Agenda Item 3
Amberley Courtyard Homes
Additional Design Option

Amberley Woods Courtyard Homes – Additional Design Option

Agenda Item 4
780 N. Western Avenue - Bank of America
Exterior Lighting

**Bank of America
780 N. Western Avenue**

BRUNSWICK TUDOR - APPROVED ELEVATIONS

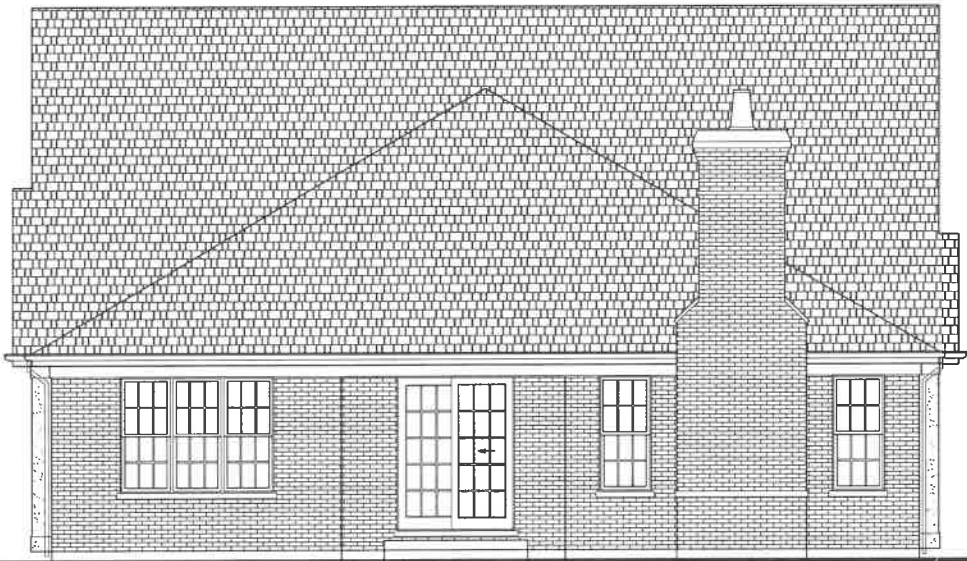
- Stone headers were added above the windows on the first floor.
 - Staff recommends approval of this change. The stone headers enhance the design of the home.
- The stucco half-timber detailing above the double window on the projecting bay was modified.
 - Staff does **NOT** recommend approval of this change. The stucco half-timber detailing as now proposed above the double window appears awkward and unintentional.
- The proportions of the stucco half-timber detailing on the second-floor gable were modified.
 - Staff recommends approval of this change due to its minor impact on the overall design of the home.

- The proportions of the double-hung window on the second-floor gable were modified. The previously approved window in the gable end presented narrower proportions.
 - Staff recommends approval of this change due to its minor impact on the overall design of the home.

- The stucco half-timber detailing above the windows on the projecting bay was modified.
 - Staff does **NOT** recommend approval of this change. The stucco half-timber detailing as now proposed above the double window appears awkward and unintentional.

- The proportions of the stucco half-timber detailing on the second-floor gable were modified.
 - Staff recommends approval of this change due to its minor impact on the overall design of the home.

1. The revised plans shall be modified to reflect the stucco half-timber detailing as originally approved.

SHEET:
2.3
LEFT

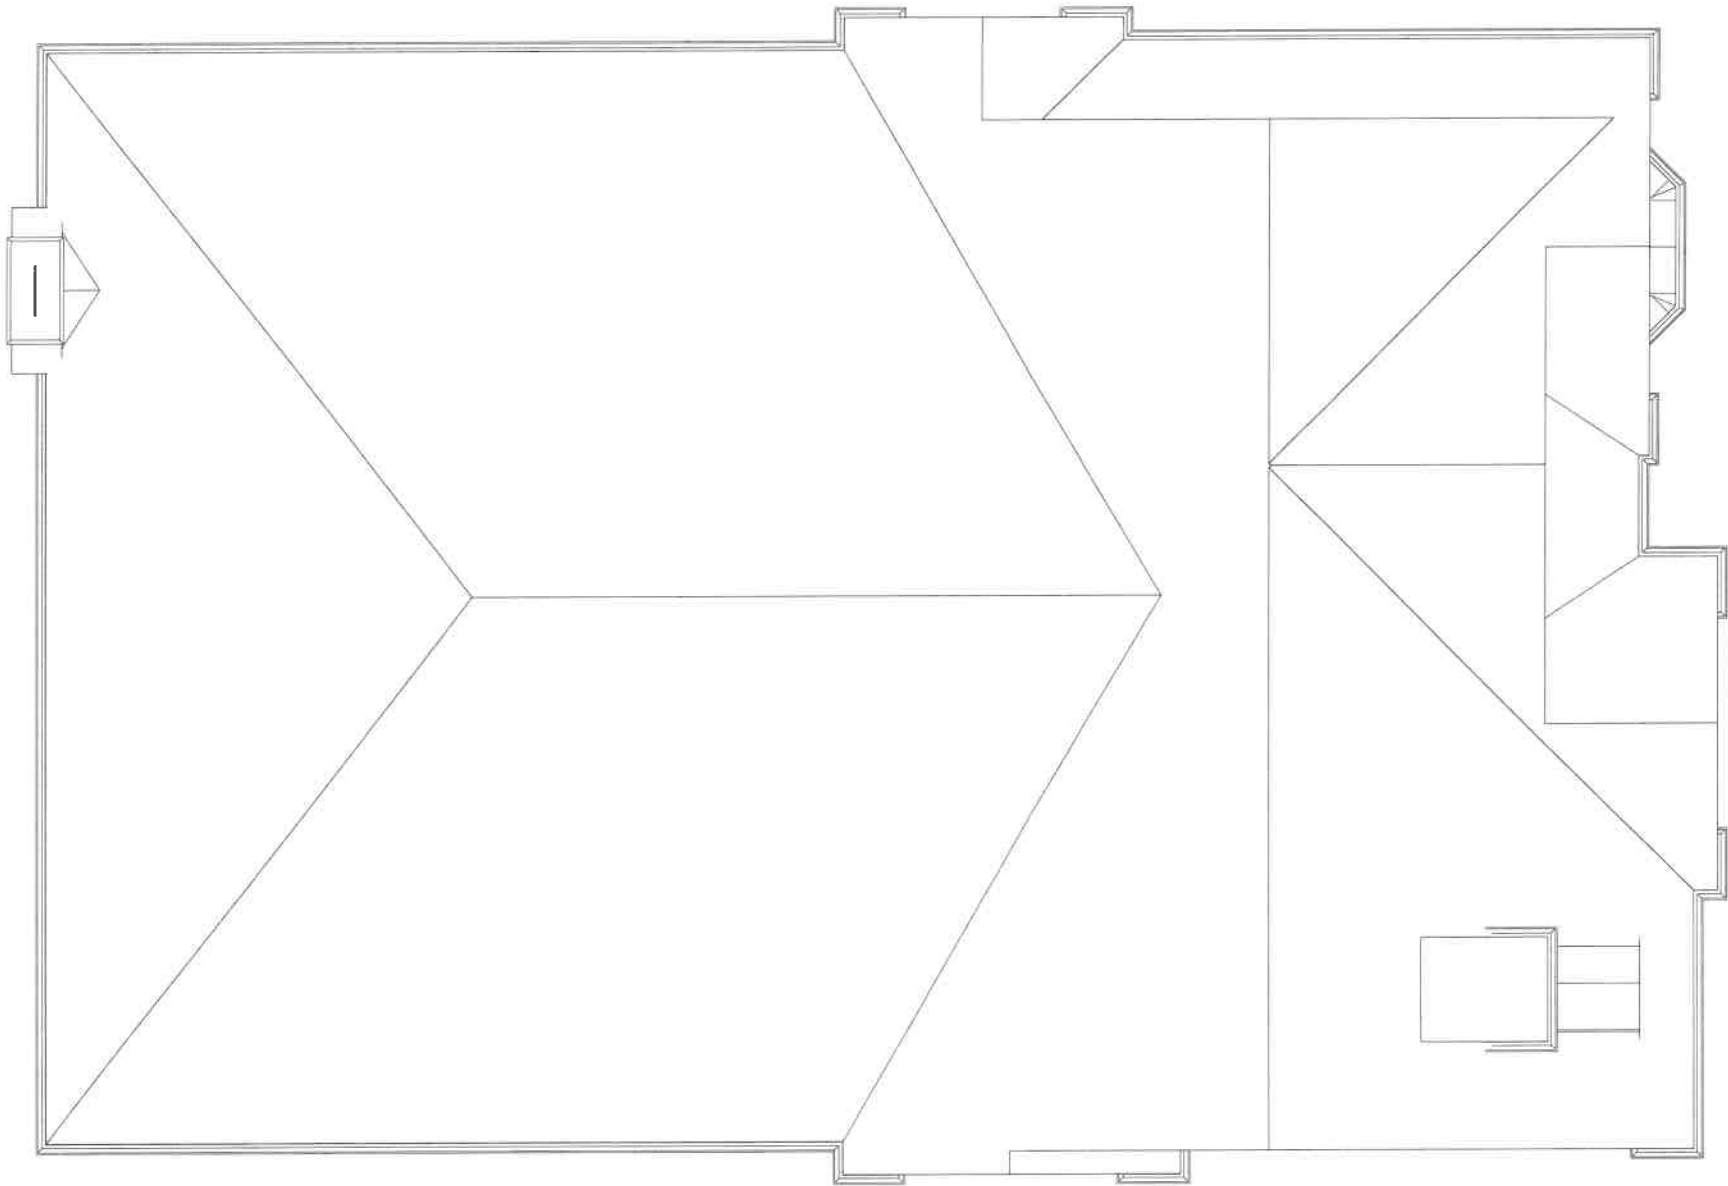
- The projecting bay was reduced in size.
 - Staff recommends approval of this change due to its minor impact on the overall design of the home and the limited visibility of the projecting bay from the streetscape.

- The proportions of the double-hung window on the second-floor gable were modified. The previously approved window in the gable end presented narrower proportions.

- Staff recommends approval of this change due to its minor impact on the overall design of the home.

COMPLIANCE AREA EXISTING CONDITIONS

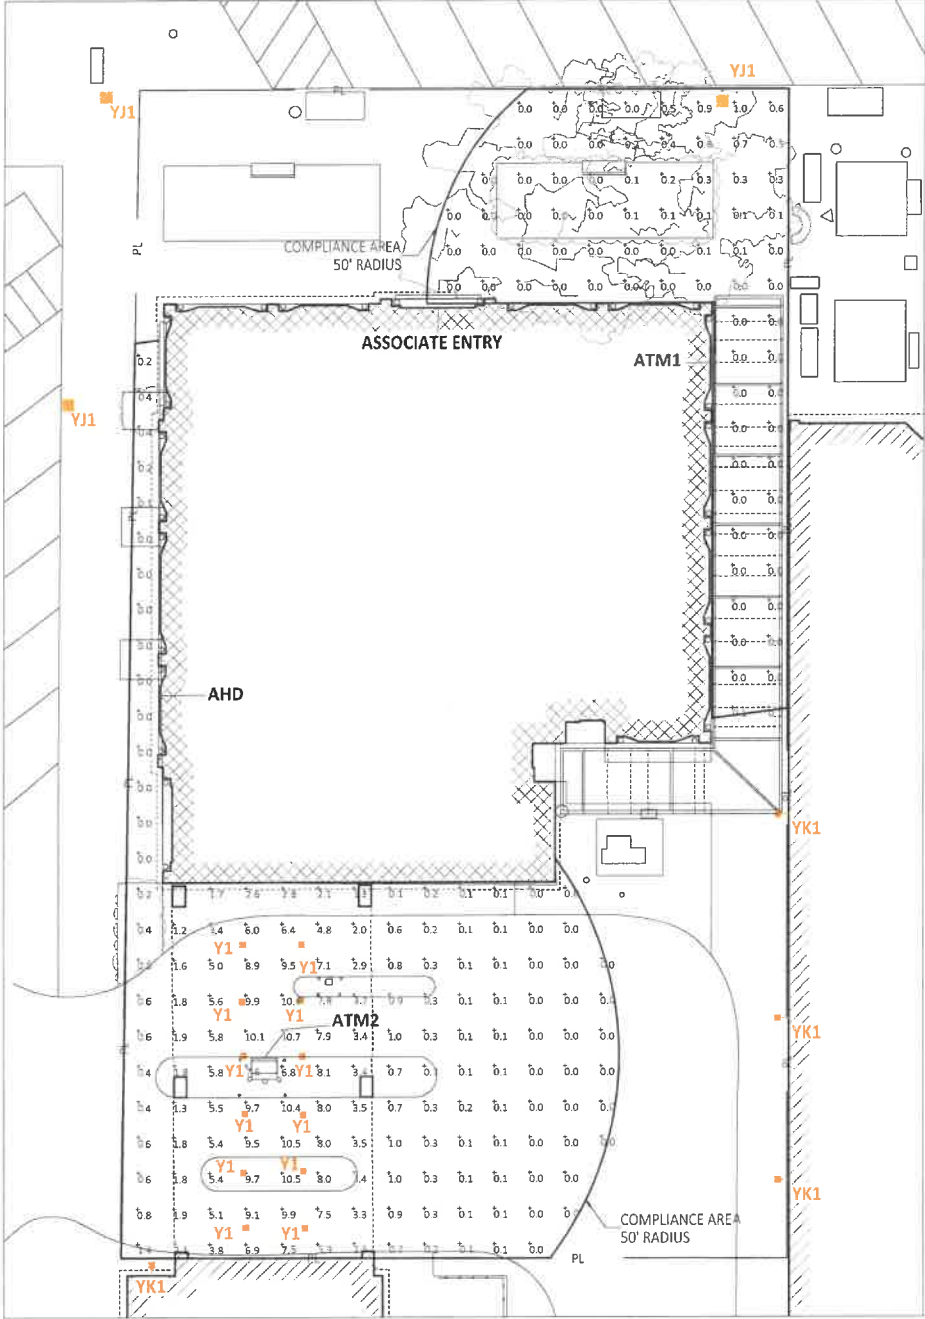
1. Provide information on the current lighting levels – **Photometrics representing “before” and “after” light levels are provided. This is located on the LU1 page under full site photometrics**
